NTA Observations on the Proposed Scheme Submissions and CPO Objections

Liffey Valley to City Centre Core Bus Corridor Scheme

National Transport Authority

26th October 2022

Figure 2-9: Extract from the Landscaping General Arrangement displaying trees lost at Mount Brown

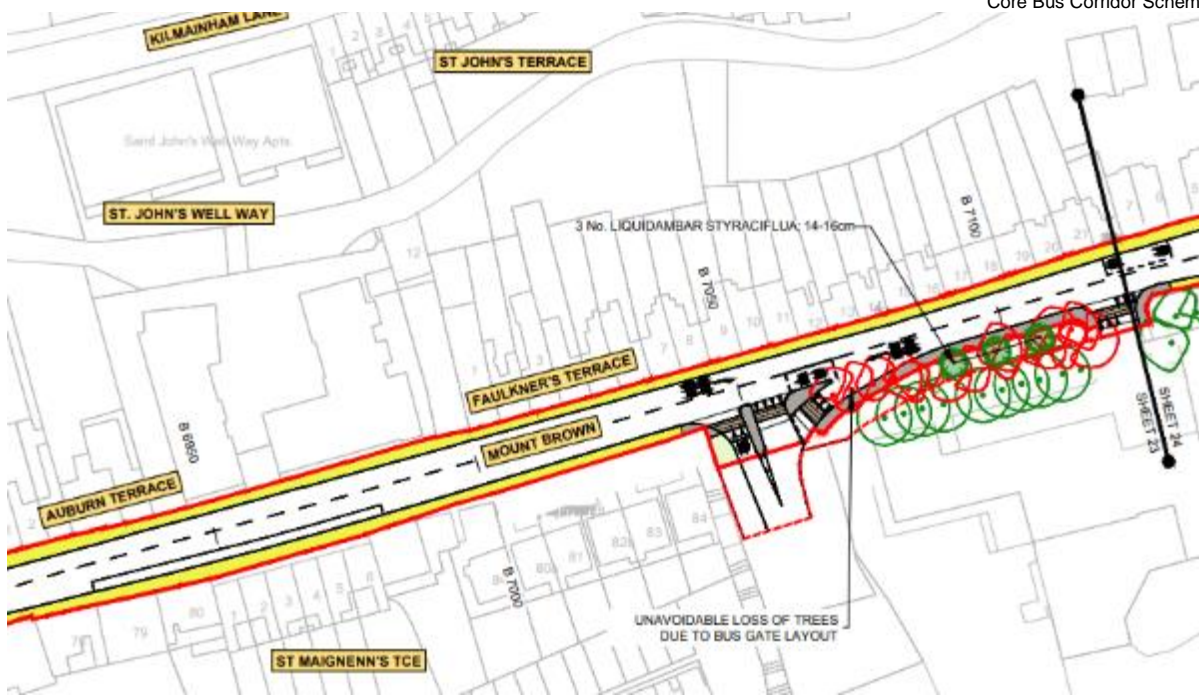
Figure 2-9, which is an extract of Landscaping General Arrangements displays the trees lost as a result of the Proposed Scheme at Mount Brown.

Figure 2-10: Extract from the Preferred Route Public Consultation Documents (March 2020)

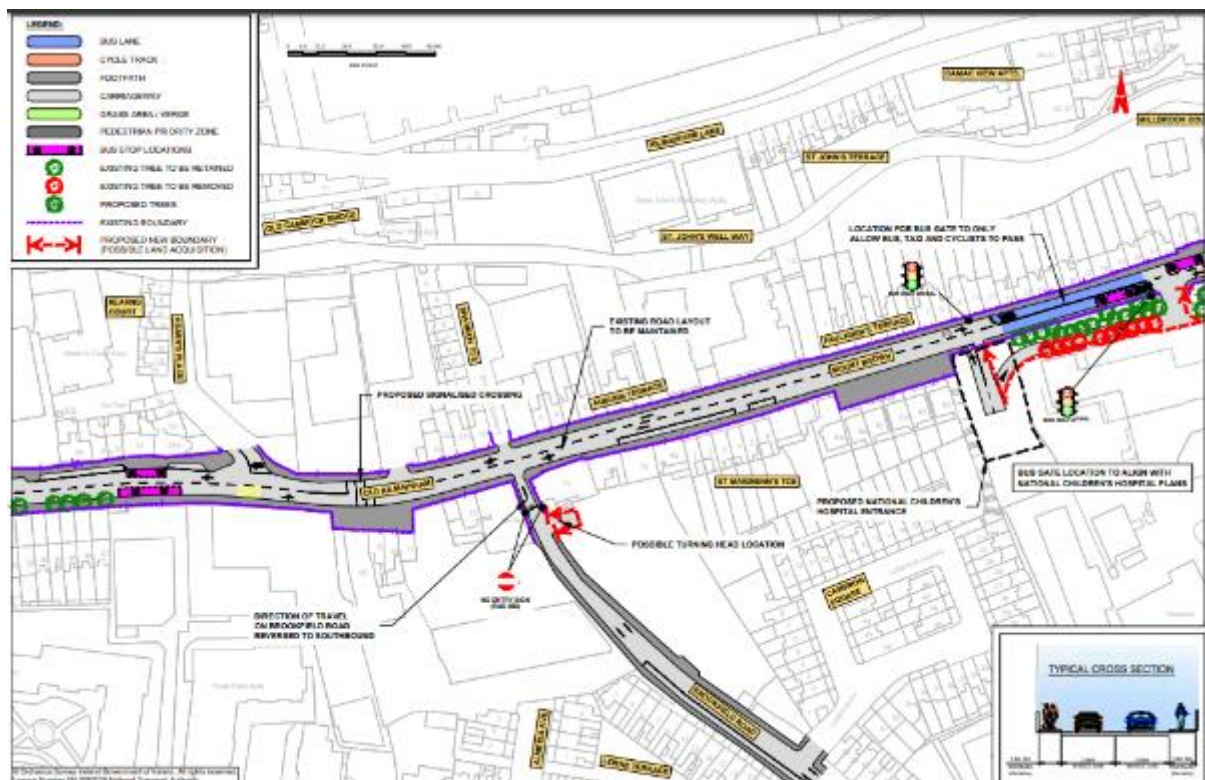
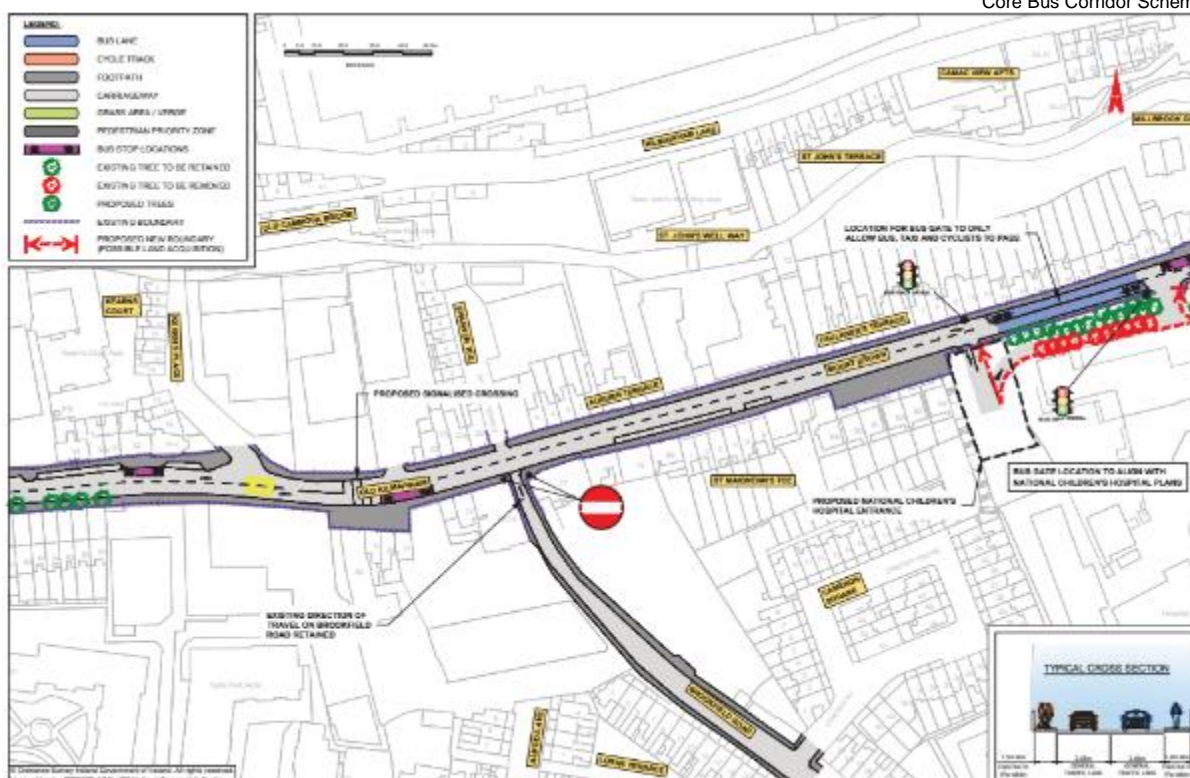
Figure 2-10 and Figure 2-11 display the design at this location as presented at the Preferred Route Public Consultation (March 2020) and Preferred Route Public Consultation (November 2020). As displayed below whilst the design differs to that displayed in the General Arrangement drawings, tree loss was previously proposed as part of the design.

Figure 2-12: Extract from General Arrangement Drawings – Sheet 23 and 24

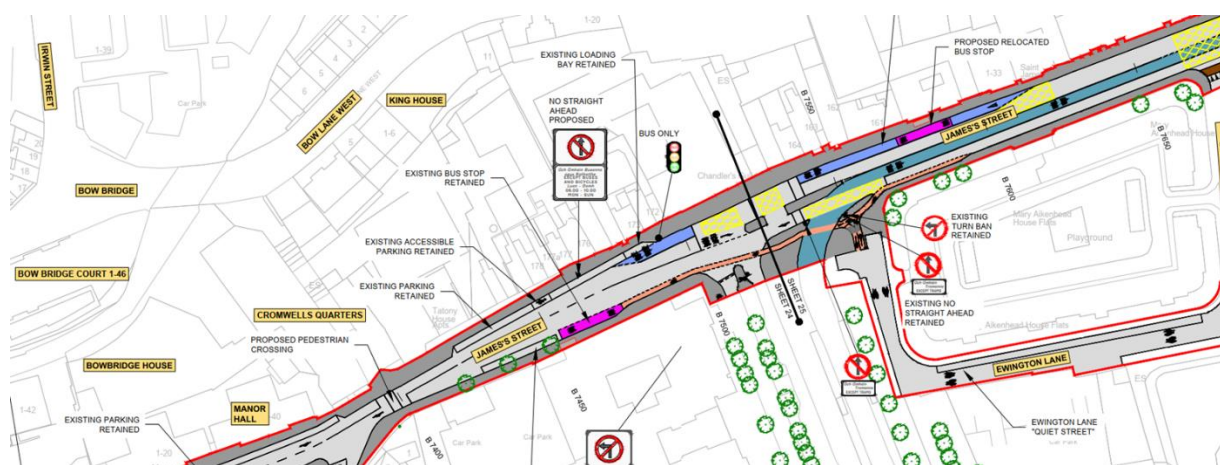
As indicated in the General Arrangement drawings, which are provided as Appendix 2 to Chapter 4 in Volume 3 of the EIAR, the bus lane markings and the necessary vehicle restrictions associated with the proposed bus gate are displayed on sheet 23 and 24 which are extracted below. As set out in Appendix A4.1 BusConnects Preliminary Design Guidance Booklet (PDGB) of the EIAR, a Bus Gate is a sign-posted short length of stand-alone bus lane.

Figure 2-17: Cornmarket area displaying the changes in parking and bus stops.

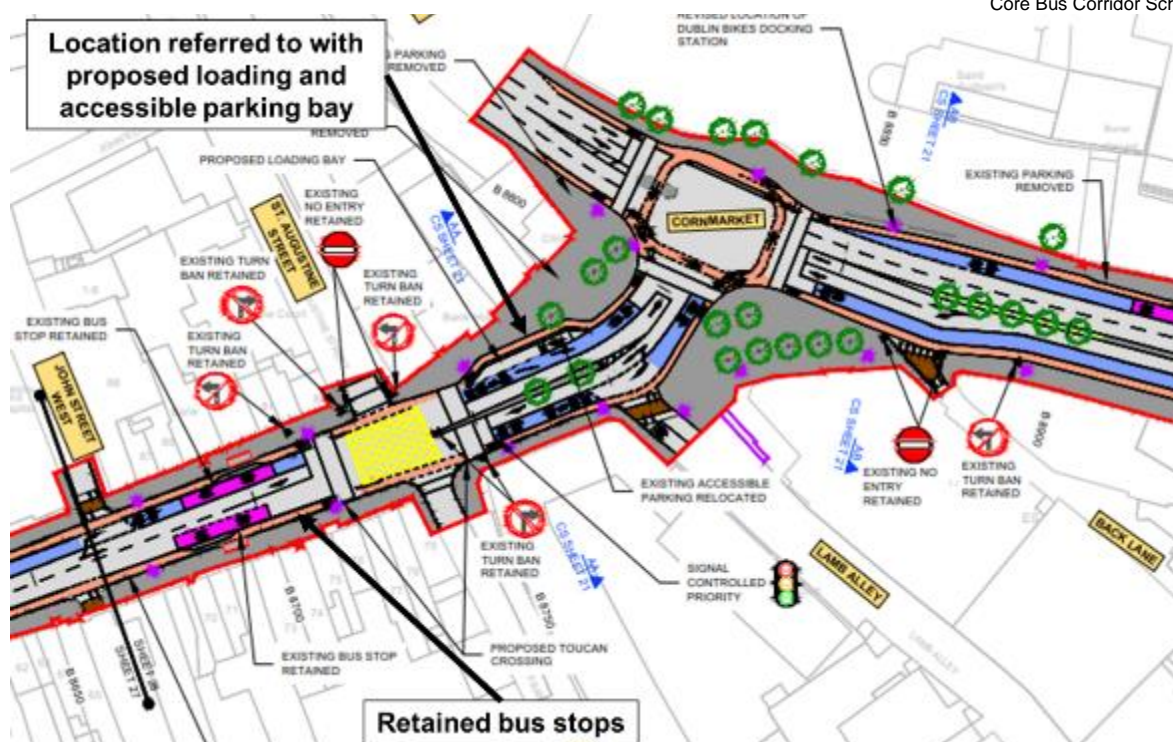
The statement that buses will be stopping / departing from a bus stop outside the respondent's apartment appears to be a misunderstanding of the proposals. It is proposed for the bus stops at Cornmarket (such as bus stops 1938, 1999, 2001 and 1937) to be retained at their current locations. It is proposed for a loading bay and disabled parking bay to be relocated to the location referred to by the respondent as shown in Figure 2-17.

Figure 2-21: Extract from Landscape General Arrangement Drawings

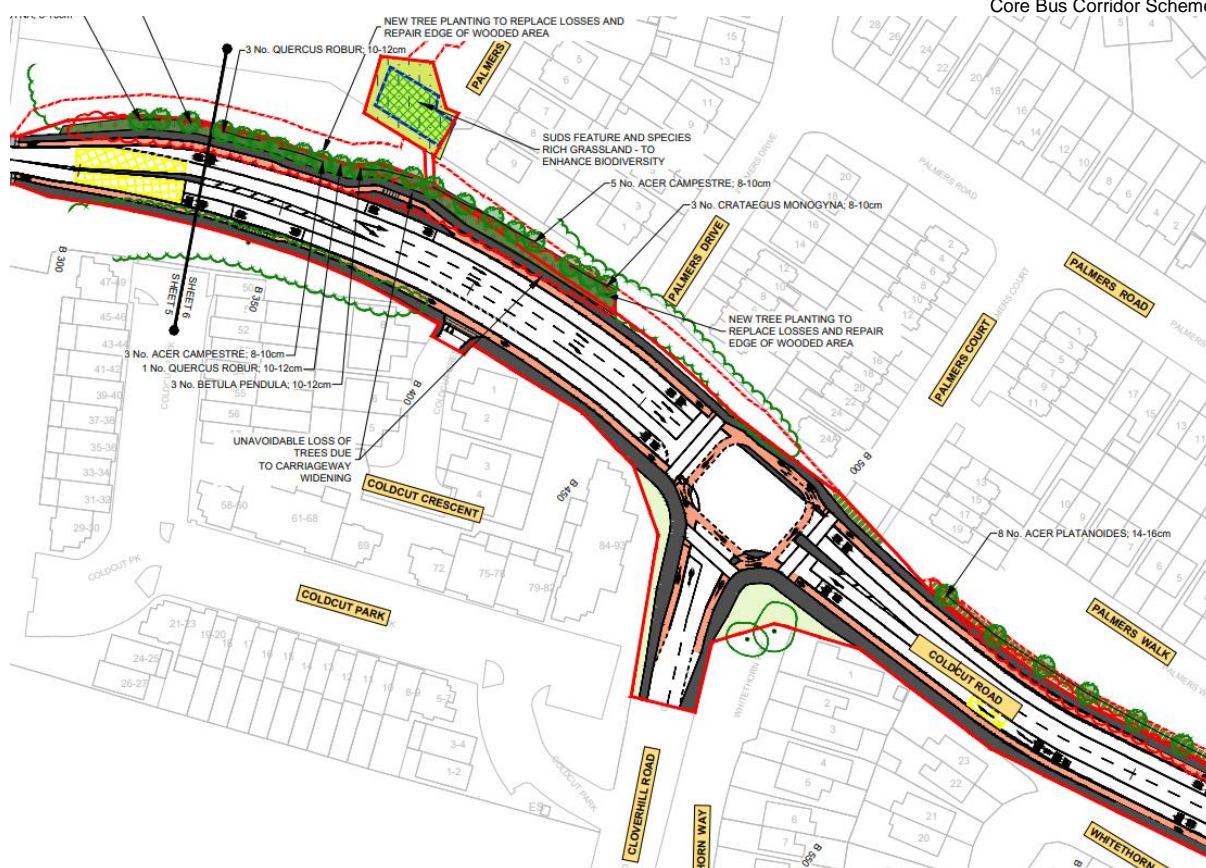
As set out in the response in Section 2.3.3.1 and displayed in the Landscape General Arrangement Drawings in Volume 3, Chapter 4 Section 5 of the EIAR, the boundary wall will be reinstated and where trees are removed, new tree planting will be provided. The reinstated boundary wall and trees are displayed in Figure 2-21.

Figure 2-27: Proposed plans at Sarsfield Road, Inchicore Road and Grattan Crescent.

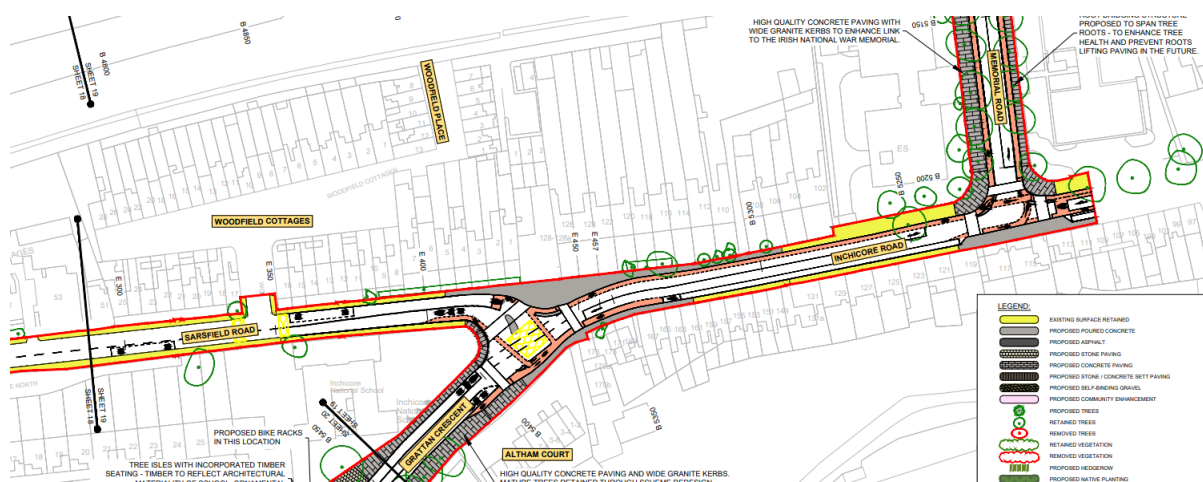
As displayed in Figure 2-27, it is proposed to retain the existing surface along the majority of Sarsfield Road (Woodfield Terrace) and Inchicore Road. At the junction of Sarsfield Road (Woodfield Terrace) / Inchicore Road / Grattan Crescent it is proposed to use poured concrete. At this location, the existing granite kerbs between properties 1-5 (which form part of the junction redesign) are proposed to be incorporated into the design, where practicable.

Figure 2-28: HGV Swept path analysis for entrance to supermarket car park

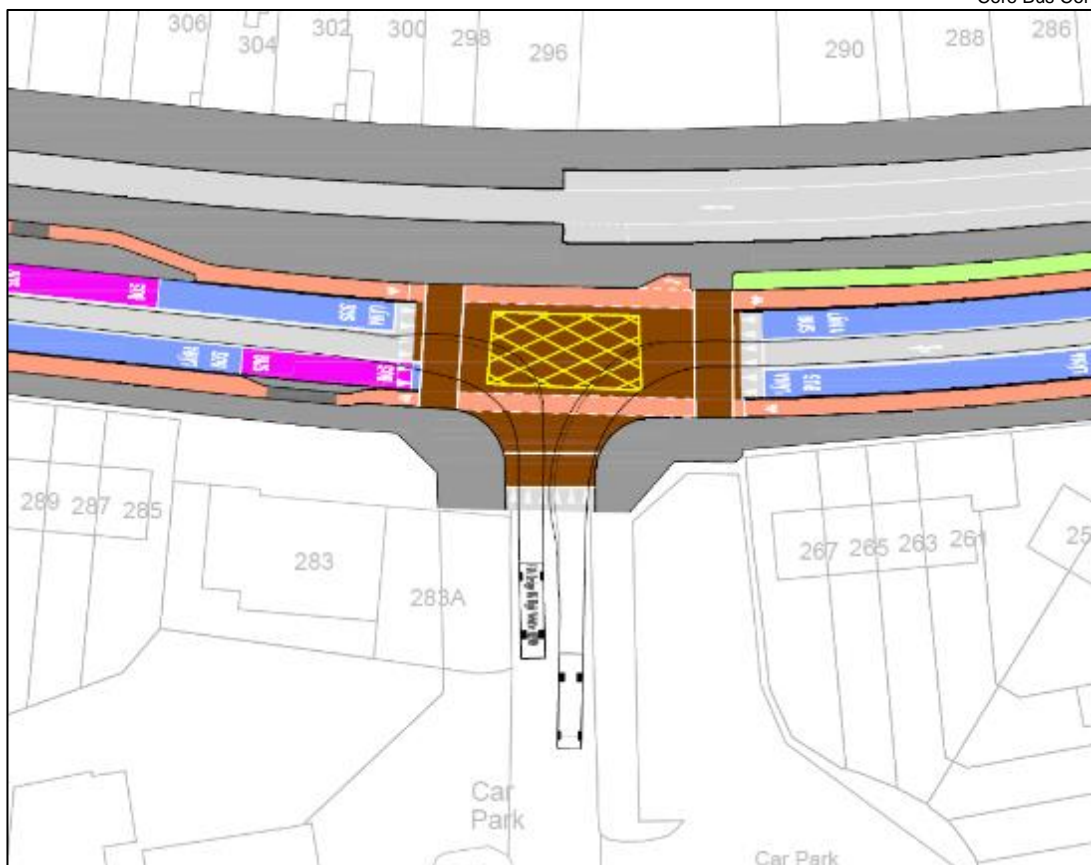
As part of the design development process swept path analyses have been undertaken at all junctions in the Proposed Scheme including this one. Figure 2-28 below shows the specific swept path analysis for the HGV movement mentioned in the submission, i.e., an approaching HGV turning from the Ballymore Road into the supermarket car park.

Figure 2-31: Extract of General Arrangement Sheet 19

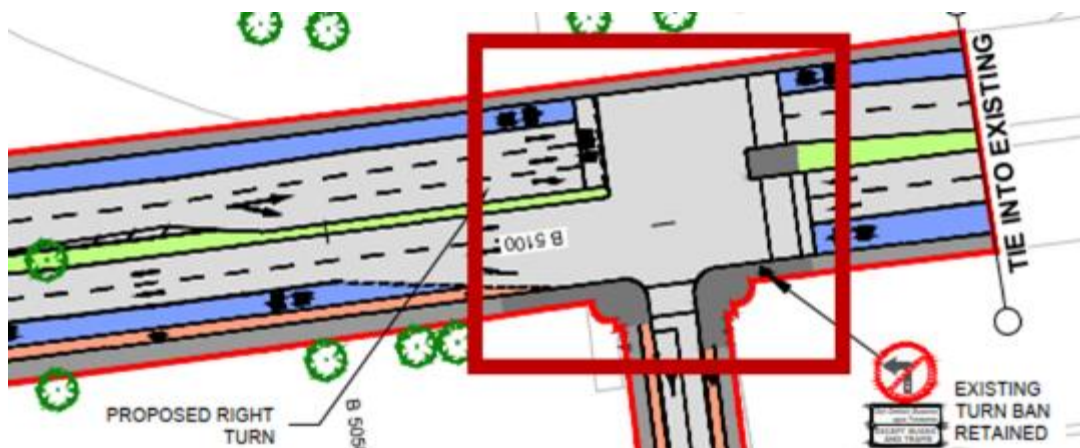
As set out in the General Arrangement drawings (EIAR Volume 3 Chapter 4 Proposed Scheme Description Figures) which are extracted in Figure 2-31 below, signalised pedestrian crossings are proposed on the eastern and southern sides of the (R148) Con Colbert Road / Memorial Road junction.

Figure 2-32: Extract of General Arrangement Sheet 19 and Sheet 20

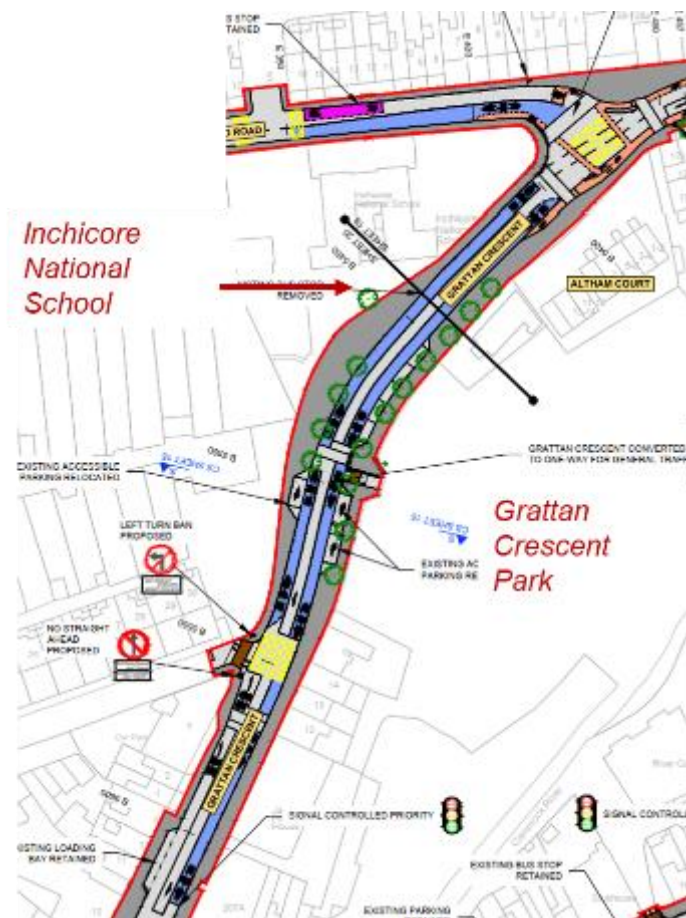
As set out in the General Arrangement drawings (EIAR Volume 3 Chapter 4 Proposed Scheme Description Figures) which are extracted in Figure 2-32 below, a new signalised pedestrian crossing is proposed adjacent to Grattan Crescent Park (Chainage B5490) and on the southern arm of the Sarsfield Road / Inchicore Road / Grattan Crescent junction.

Figure 2-33: Extract of General Arrangement Sheet 20

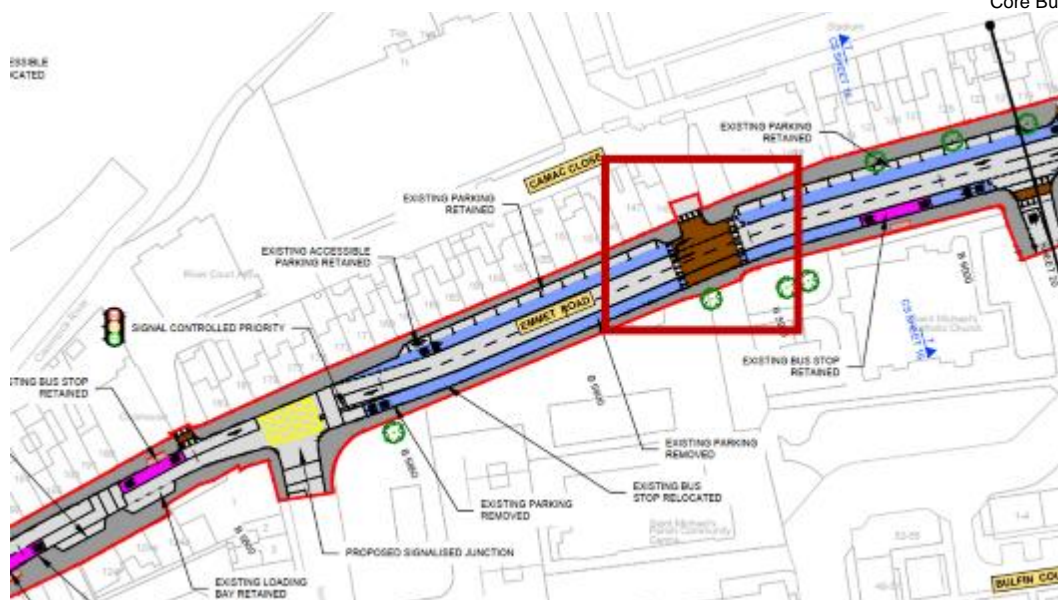
At this location it is proposed to enhance the current provision to provide a raised table across the junction, as shown in the General Arrangement drawings (EIAR Volume 3 Chapter 4 Proposed Scheme Description Figures) which are extracted in Figure 2-33 below. A signalised pedestrian crossings is proposed approximately 100m west of the St Patrick's Athletic FC Richmond Park access at the St Vincent Street West junction. Additionally, the existing mid-link crossing located approximately 100m east of the St Patrick's Athletic FC Richmond Park access to the east of Buffin Road it proposed to be upgraded.

Figure 3-14: Proposed retaining wall plans

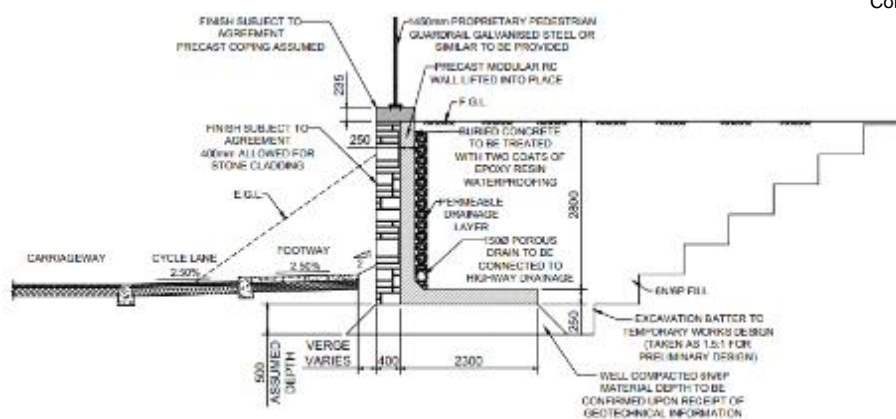
The detail of the proposed retaining wall at this location can be seen in the Structures Preliminary Design Report included as Appendix J of the Preliminary Design Report provided in the Supplementary Information.

Figure 3-16: Proposed retaining wall detail

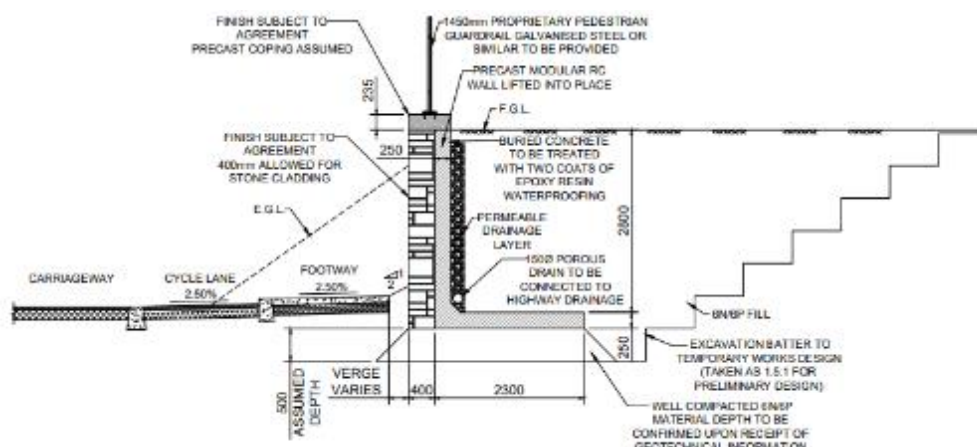
The detail of the proposed retaining wall at this location can be seen in the Structures Preliminary Design Report included as Appendix J of the Preliminary Design Report.
